**Subject:** Final Response to Request for Additional Information Related to NEI 12-16, *Guidance for Performing Criticality Analyses of Fuel Storage at Light Water Reactor Power Plants*, and EPRI Report 3002003073, "Sensitivity Analysis for Spent Fuel Pool Criticality" and NEI 12-16, Revision 2 – DRAFT A

**Project Number: 689**

**Response to Request for Additional Information Related to NEI 12-16, *Guidance for Performing Criticality Analyses of Fuel Storage at Light Water Reactor Power Plants*, and EPRI Report 3002003073, "Sensitivity Analysis for Spent Fuel Pool Criticality"**

Figure 4-5: BWR Peak Reactivity Depletion Uncertainty

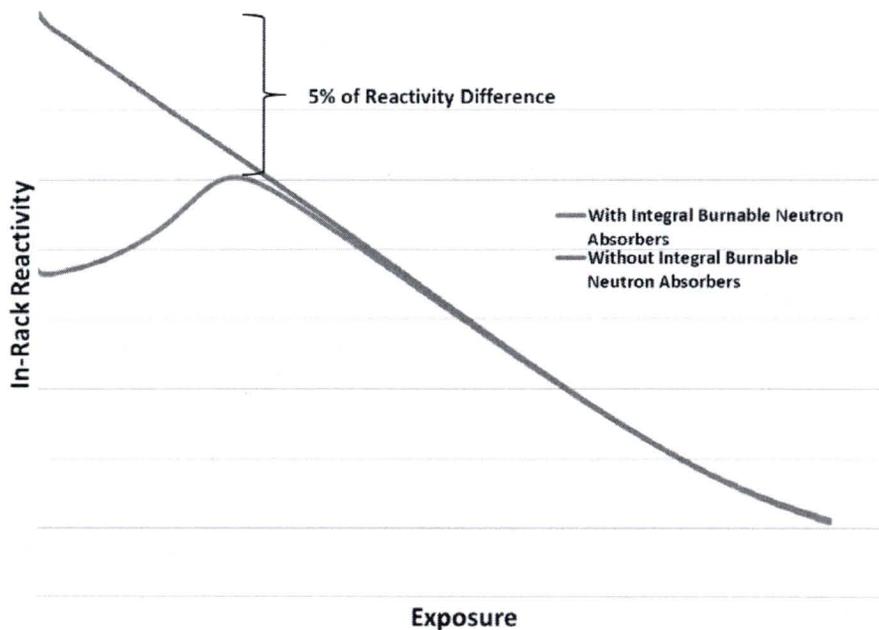
22. Section 4.3.2 discusses the determination of BWR depletion uncertainty. Revise this section to provide more comprehensive guidance on the calculation of BWR depletion uncertainty by addressing the following topics:

The determination of the reactivity decrement when Gadolinia is not credited would also be based on the design basis lattice. Figure 4-5 of NEI 12-16 demonstrates pictorially how the reactivity decrement is calculated when Gadolinium is credited. The depletion uncertainty would be 5% of the
